STATE OF MAINE
DEPARTMENT OF TRANSPORTATION
16 STATE HOUSE STATION
AUGUSTA, MAINE
04333-0016

December 28, 2006
Subject: **Topsham**
Pin No. 14062.11
Amendment No. 2

Work under this contract is generally described as the construction of the MaineDOT TOPSHAM HIGHWAY MAINTENANCE GARAGE

DATE 05-19-06	SCALE AS SHOWN	JOB NO	DRAWING NO
BY L P Pelletier	CHKD	LP ENG 300-01-06	H-1A

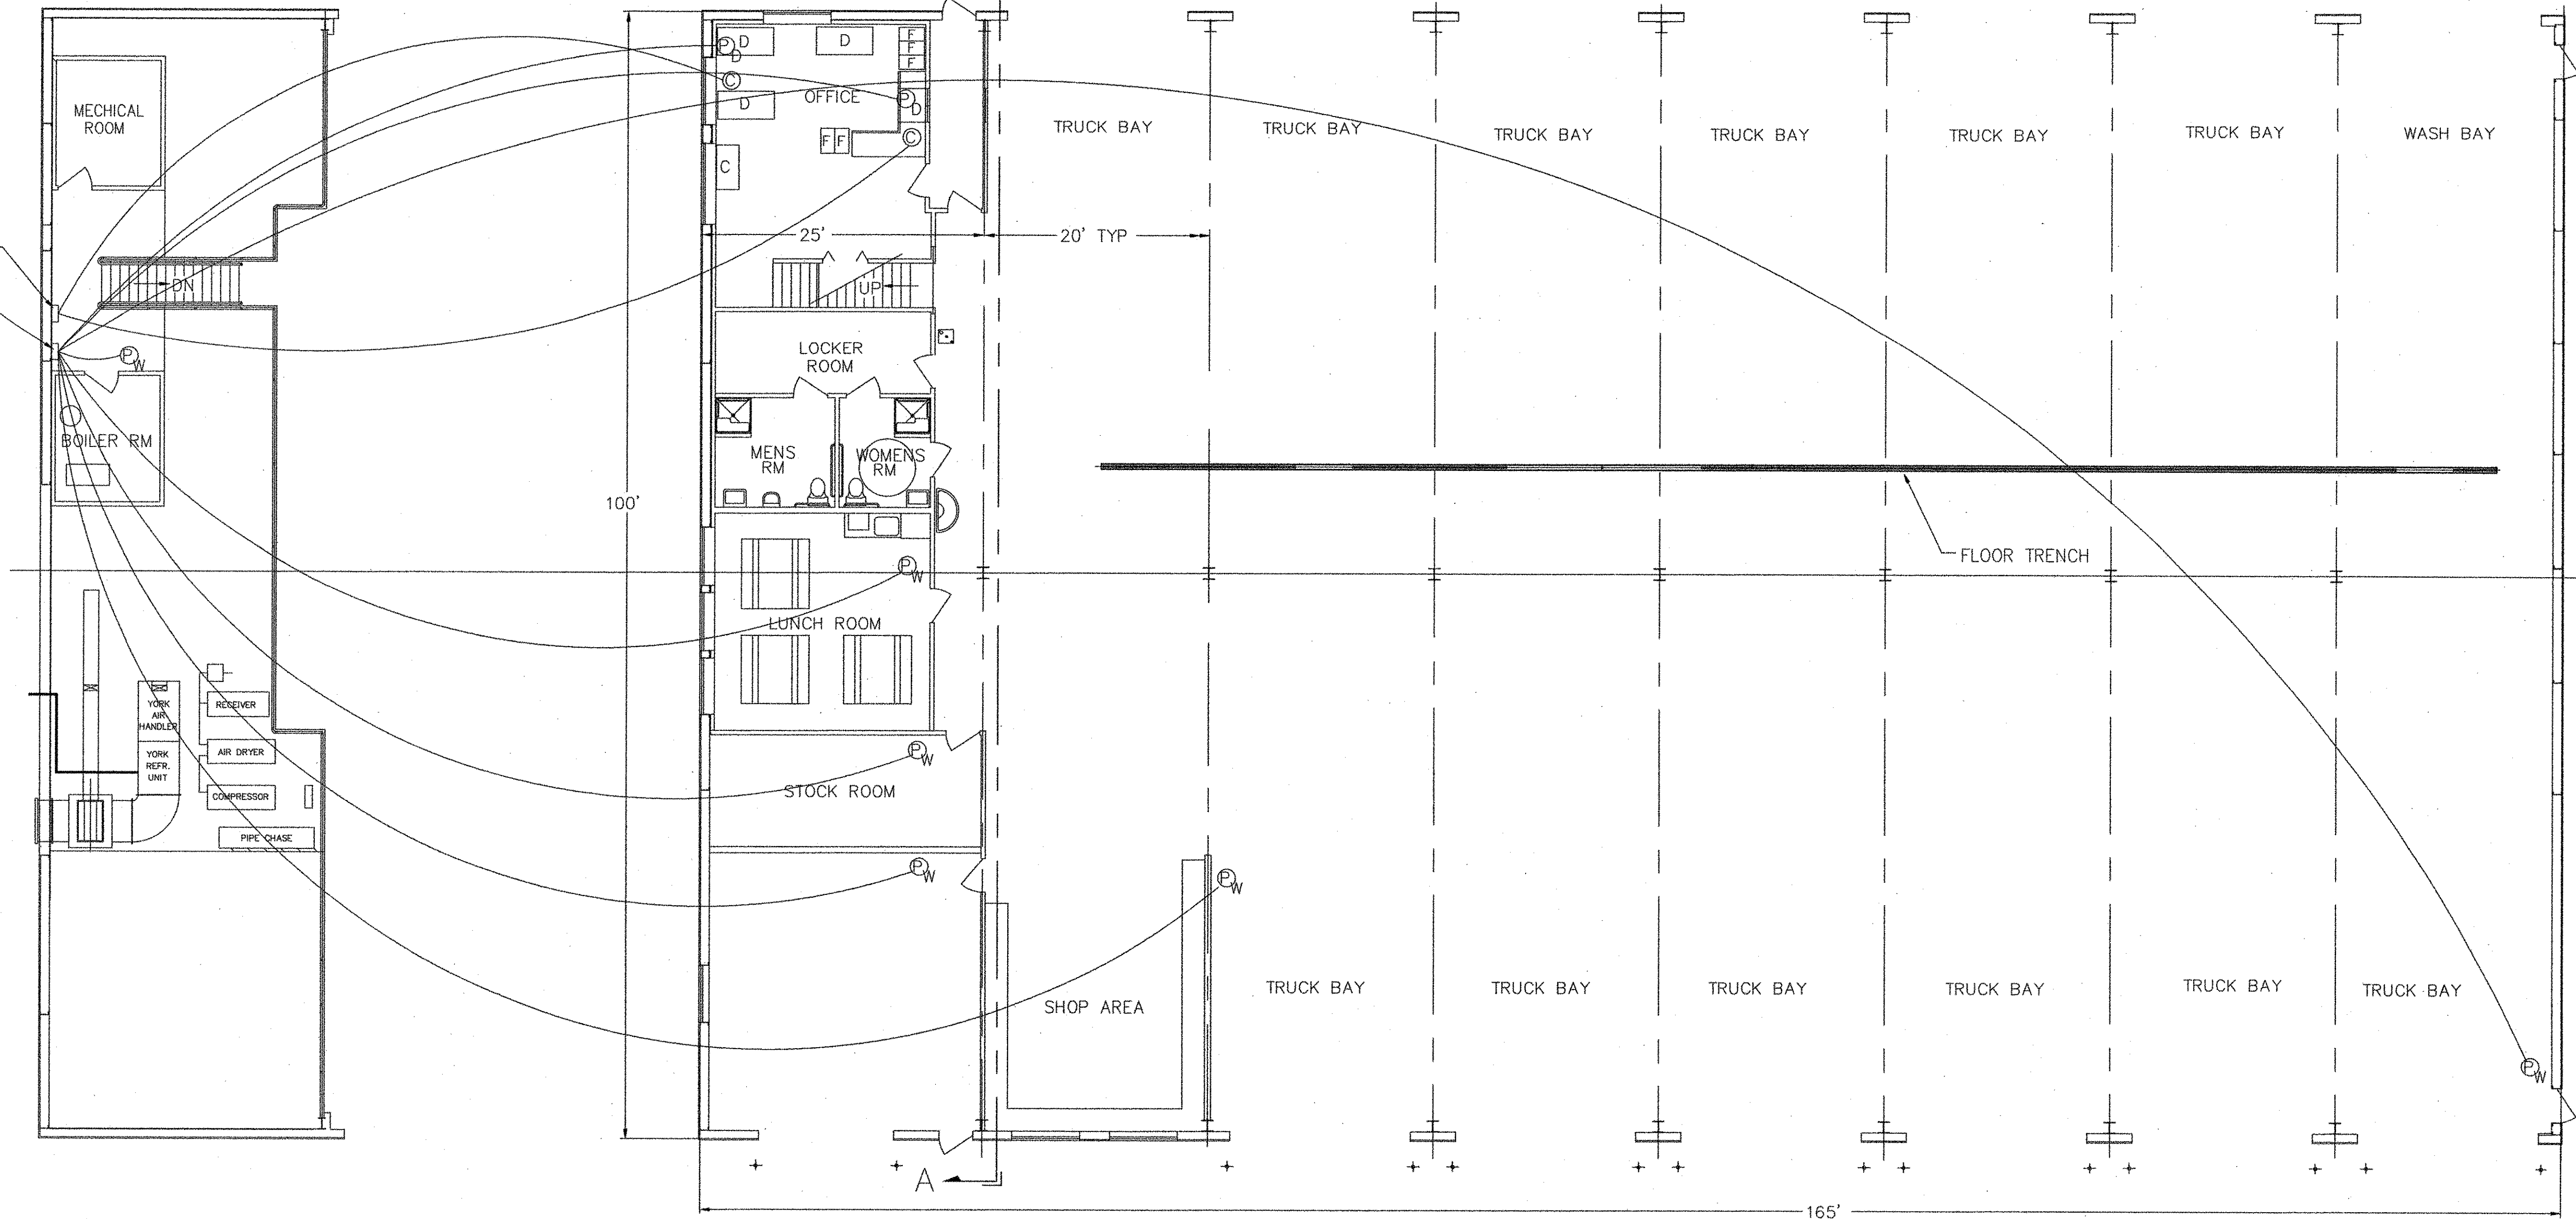
Question: There appears to be no heat in the office areas.

Response: Radiant heat in the office has been added to the attached updated Drawing H-1A.

DATE 05-19-06	SCALE AS SHOWN	JOB NO LP ENG 300-01-06	DRAWING NO E-3B
BY L.P. Pelletier	CHKD

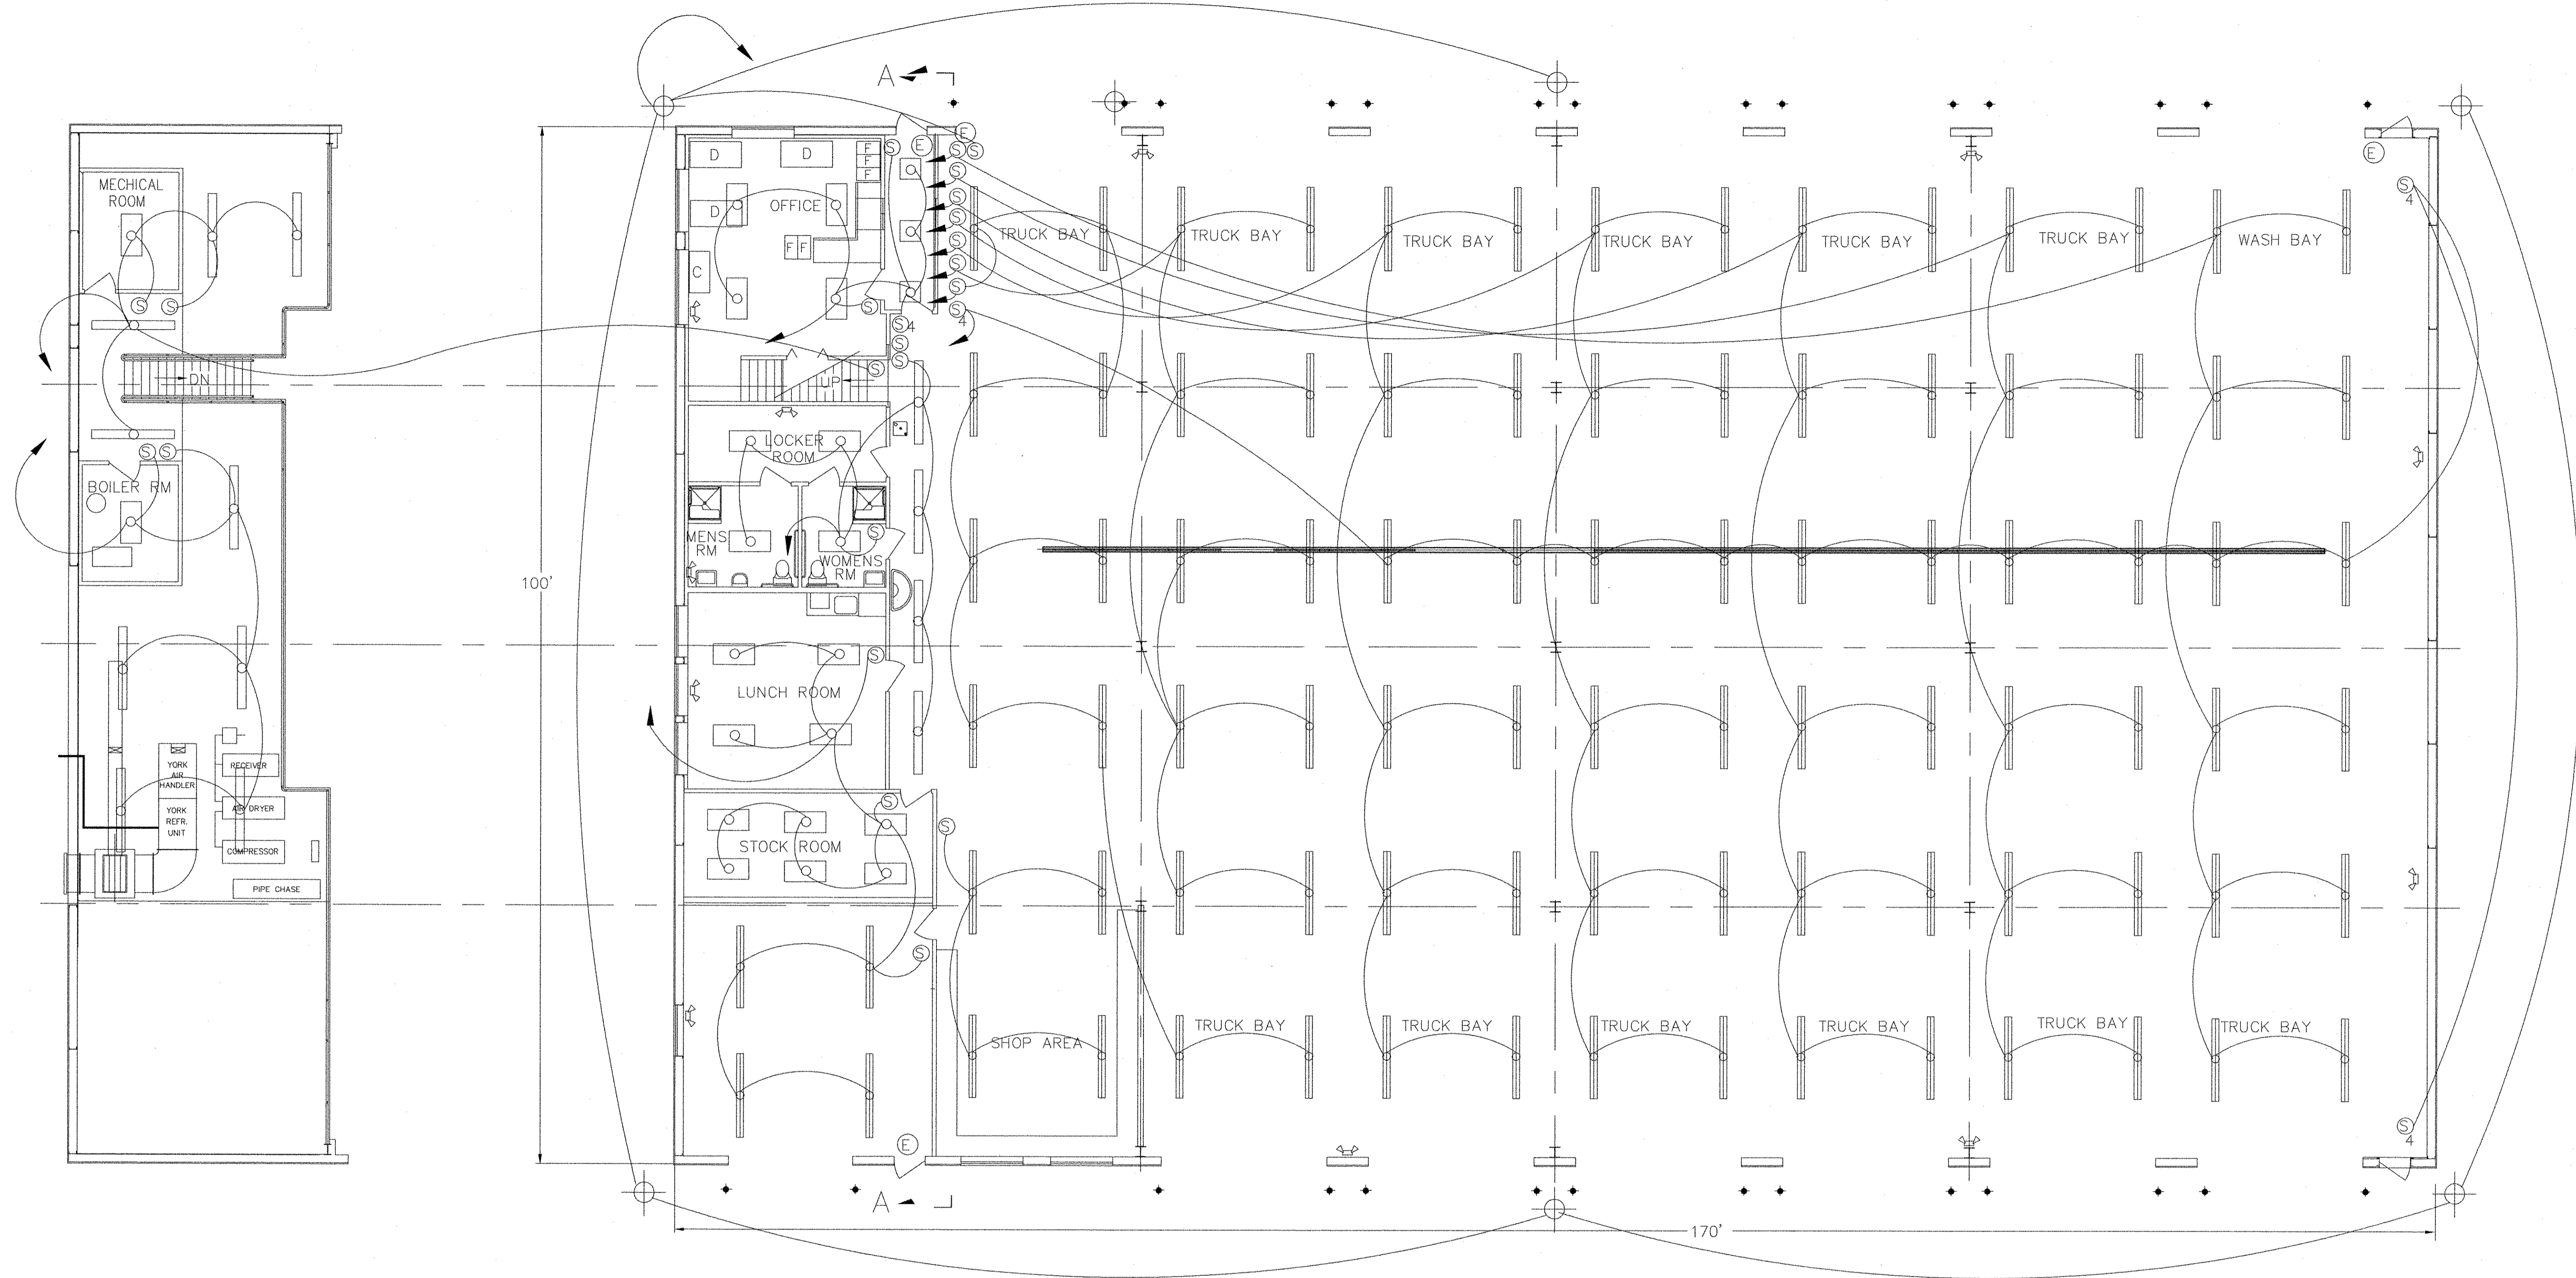
Question: There is no description (make or model) for the 1'-0" x 4'-0" fixtures in front of office area or the upstairs area. Is there a preferred fixture type? Also there are three 2x2 fixtures in front of office area. Is there a preferred fixture type for these? Are the light fixtures in boiler room and mechanical room to match office lights? If so, give make and model. All questions reference Drawing E-3.

Response: All light fixtures are described on the attached new drawing E-3A, Notes 1,2 and 7. Lights in Mechanical Room are the same as in the office.
